ECN/PCN No.: M1365

Product Description: Low Profile Shielded SMD Chip Power Inductor	Abracon Part Number / Part Series: ASPI-0628 Series	<input type="checkbox"/> Documentation only <input checked="" type="checkbox"/> ECN <input type="checkbox"/> EOL	<input checked="" type="checkbox"/> Series <input type="checkbox"/> Part Number(s)
Affected Revision: B	New Revision: C	Application:	<input type="checkbox"/> Safety <input checked="" type="checkbox"/> Non-Safety

ECN:	M1365
Product:	ASPI-0628

4.0 Part Number Identification

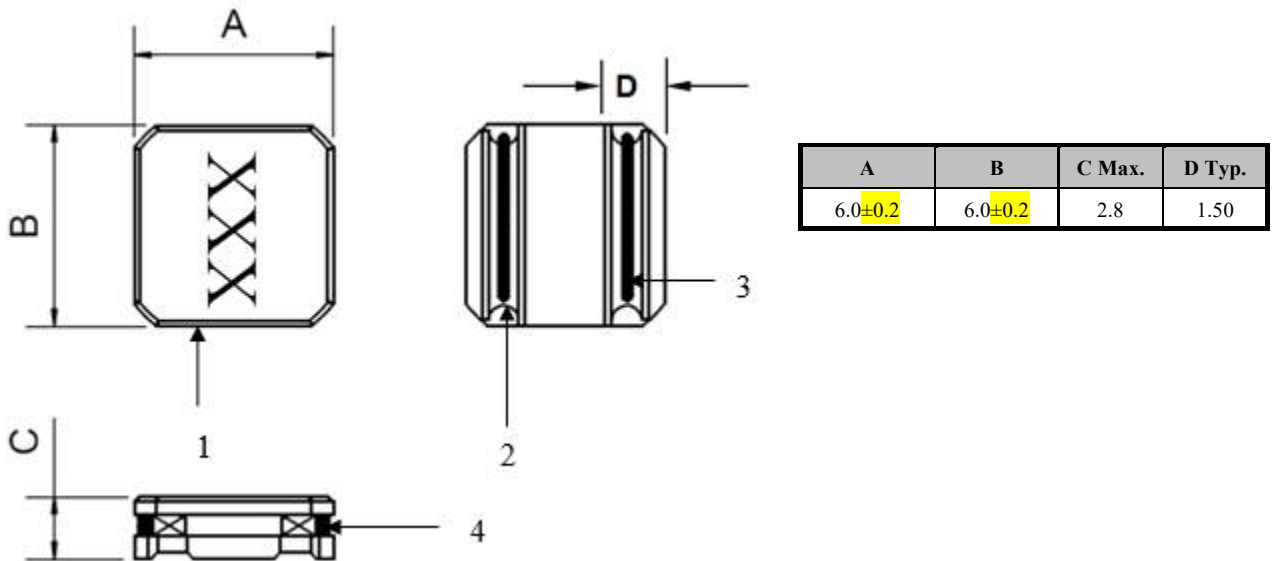
Prior to Change:

6.2 Recommended Land Pattern

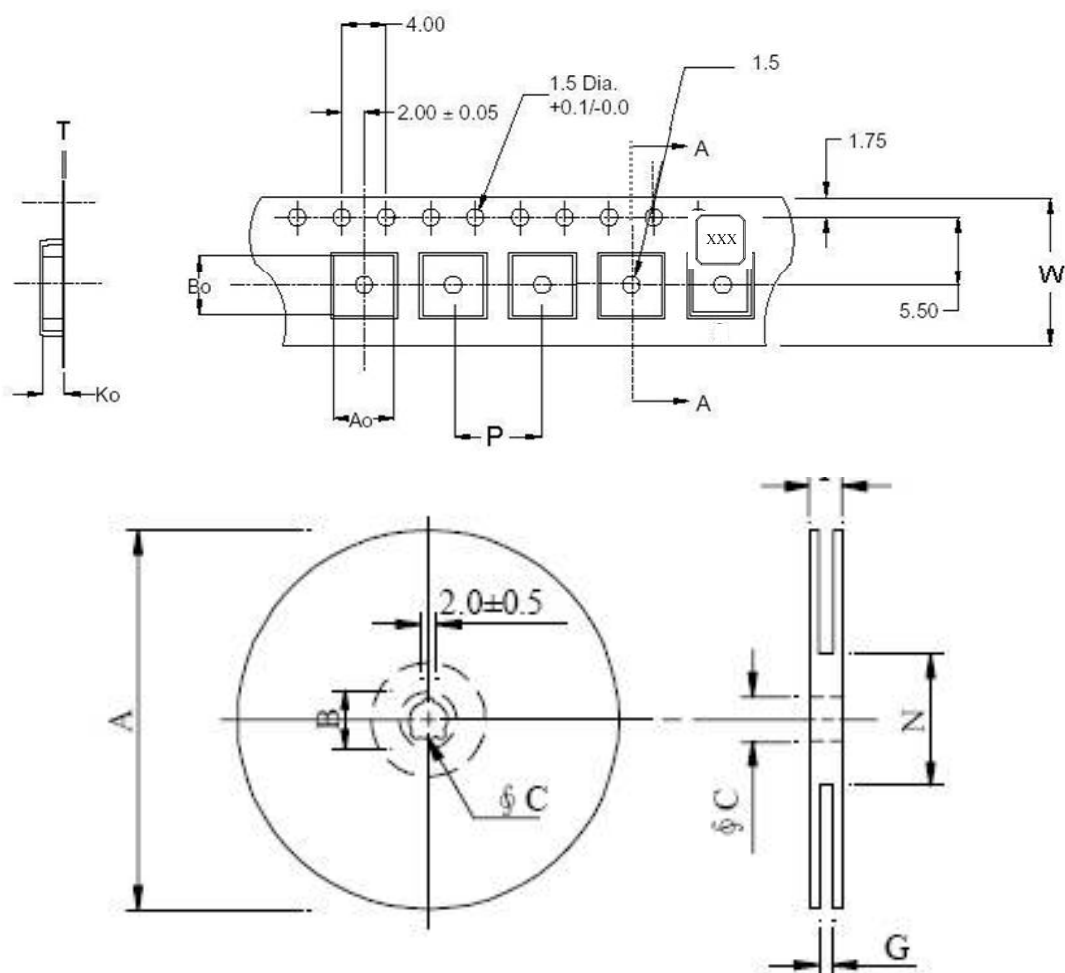
8.0 Packing T1: 1,000pcs / reel

Ao	6.40
Bo	6.40
Ko	3.05
W	16.00
P	12.00
T	0.40

A	330
B	21.0±0.8
C	13.5±0.5
G	16.6
N	99.5
T	21

Part Identification

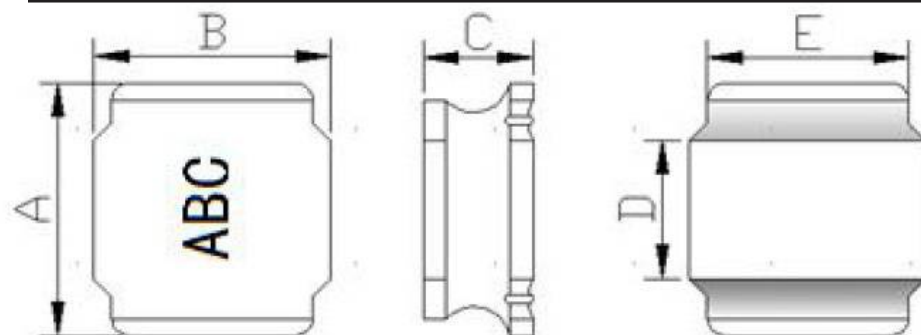
Tolerance
N: $\pm 30\%^*$
M: $\pm 20\%^*$

Packaging
T1: Tape and Reel (2kpcs / reel)

*N for L = 0.9 ~ 3.0 μ H

*M for L = 3.3 ~ 100 μ H

Mechanical Specifications

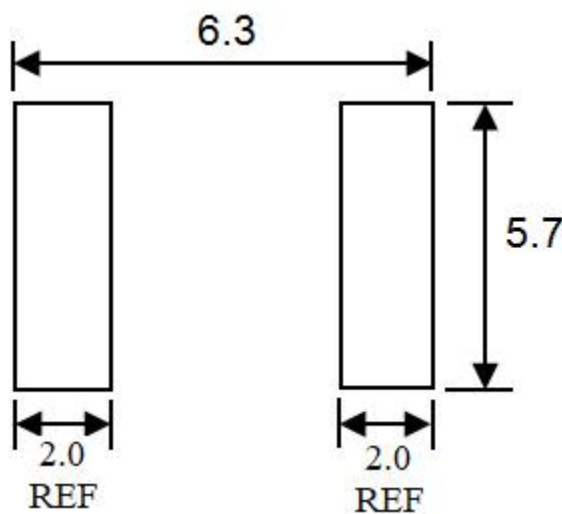
A	B	C Max.	D Typ.
6.0 \pm 0.3	6.0 \pm 0.3	2.8	1.50

Packaging

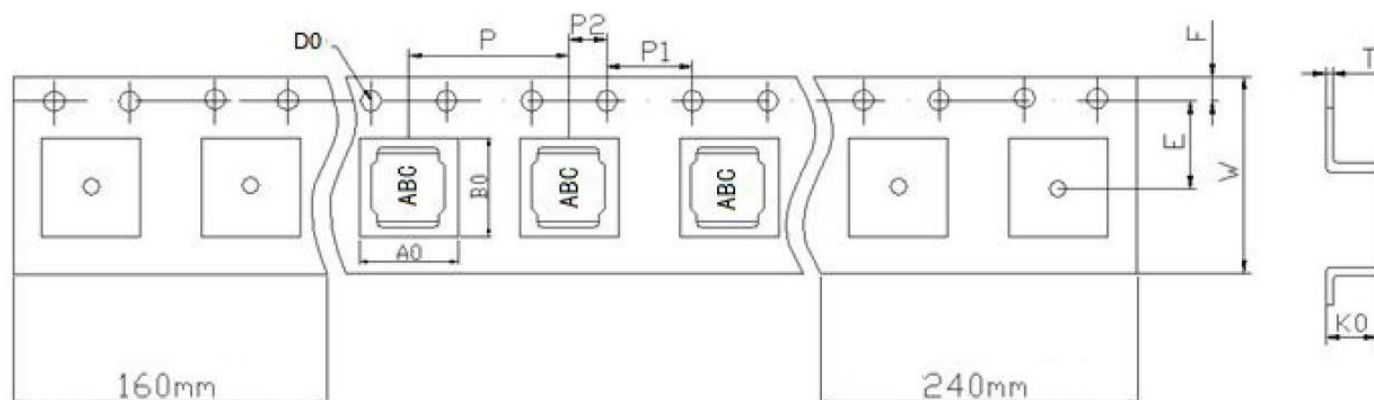
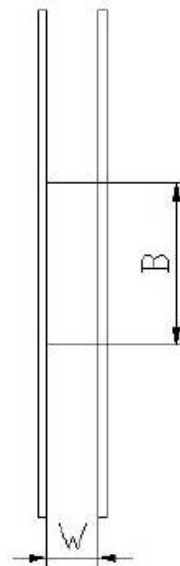
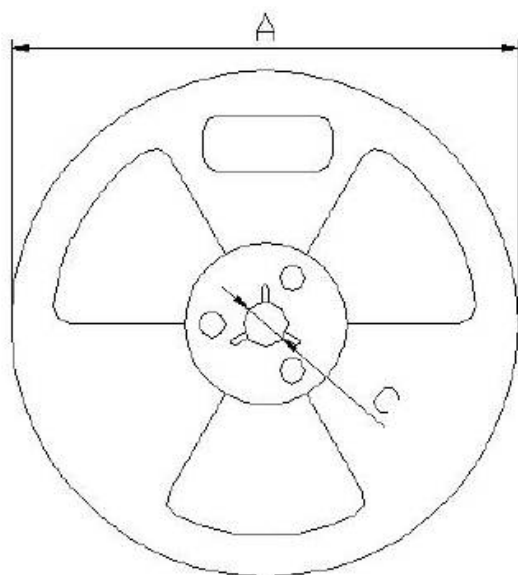
T1: 2,000pcs / reel

Dim	W	A0	B0	K0	P	E	F	D0	P0	P2	T
ASPI-0615FS	12.0±0.3	6.3±0.1	6.3±0.1	3.0 ±0.1	8.0±0.1	7.5±0.1	1.75±0.1	1.5±0.1	4.0±0.1	2.0±0.1	0.35±0.05

A	330±0.5
B	100±0.5
C	13.5±0.5
W	12.5±0.5
